ROAD SAFETY AUDIT- STAGE 1

Proposed Residential Development

Chapelgate, Hepworth

Chippings, Hepworth
Proposed Access & Internal Layout
Stage 1 Road Safety Audit

SWEPT PATH ANALYSIS

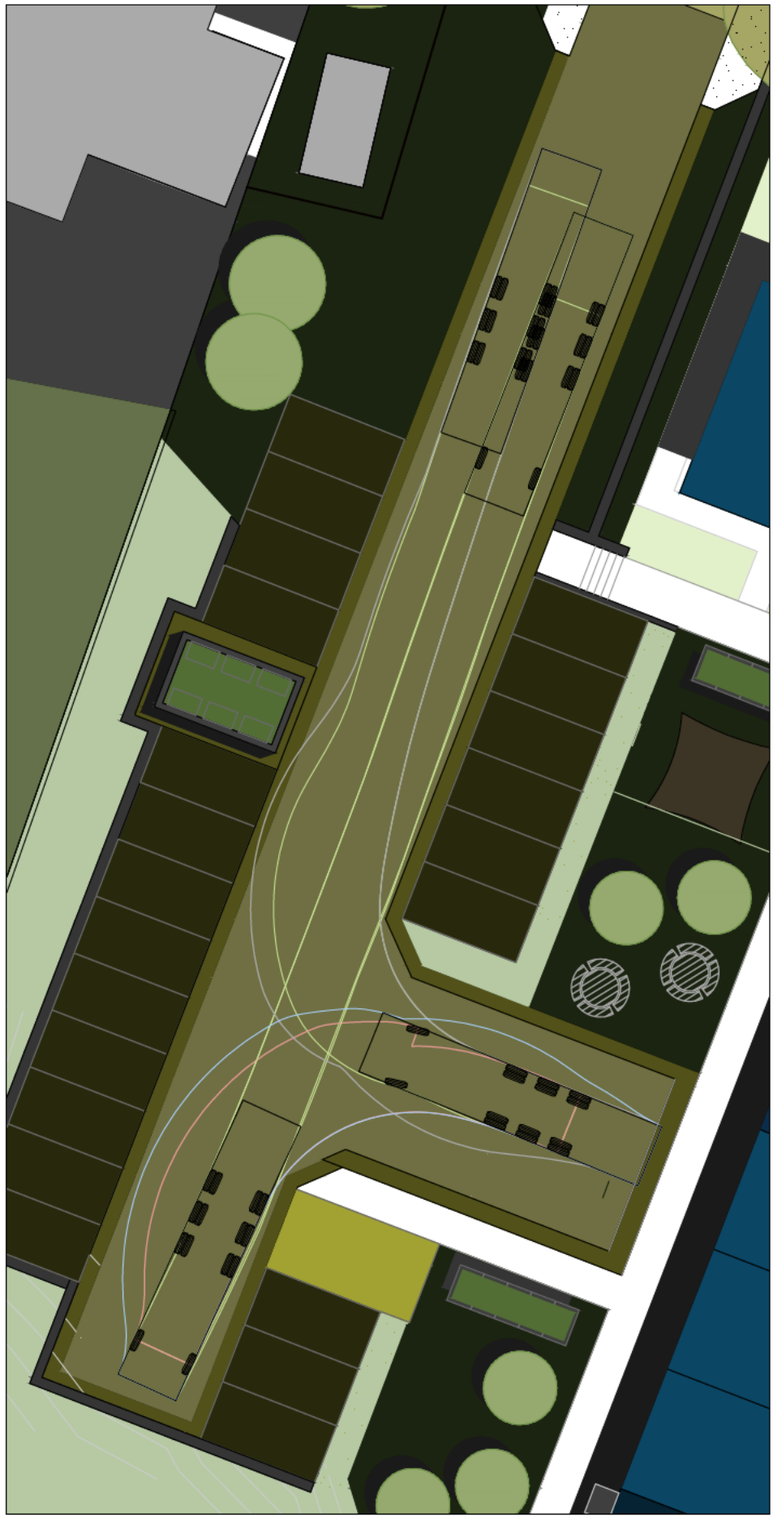
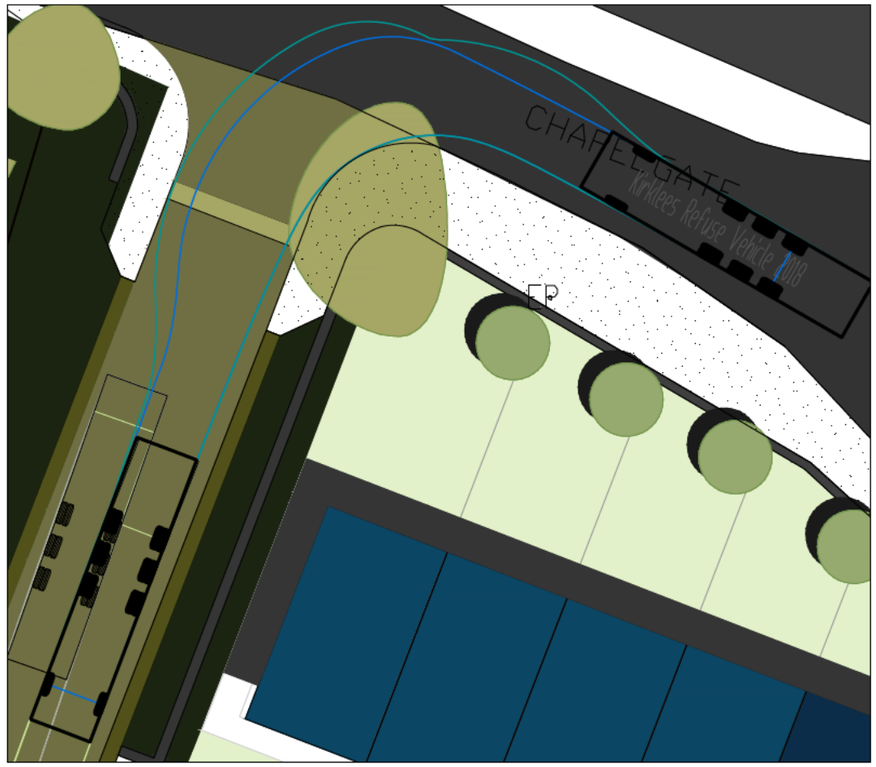
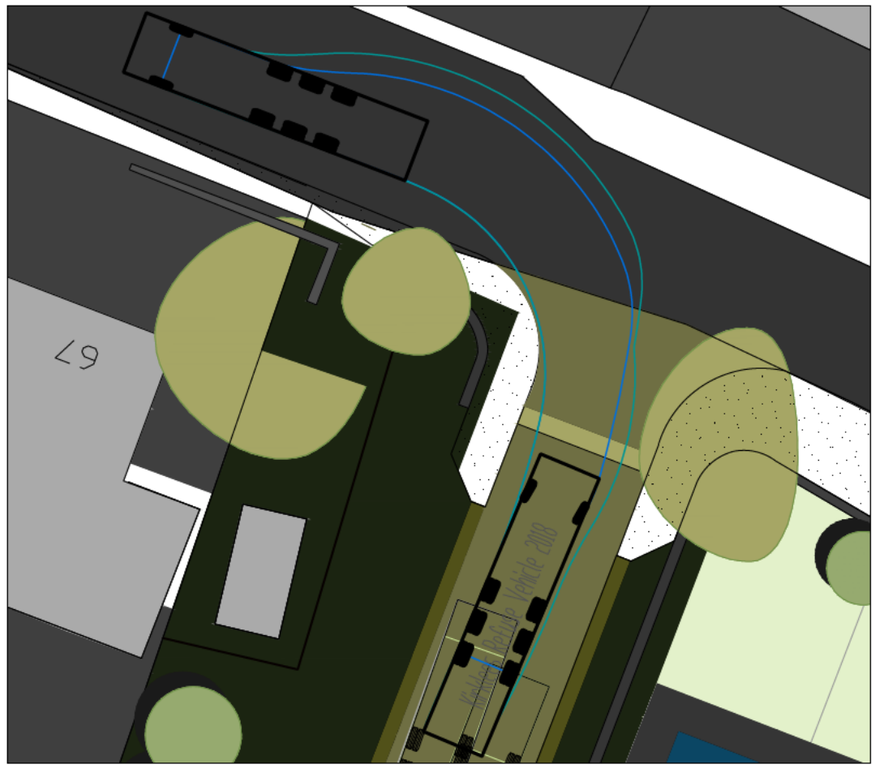
1 Problem: Proposed turning head

The proposed turning head may lead to large vehicles reversing over excessive distances.

It is recommended that the turning head is tested using a standard Kirklees refuse vehicle and increased in size accordingly.

Recommendation accepted – The swept path analysis was undertaken by the 11.85m refuse vehicle however there is a discrepancy in the architect's plan regarding the vehicle dimensions. This is shown on the revised site layout.
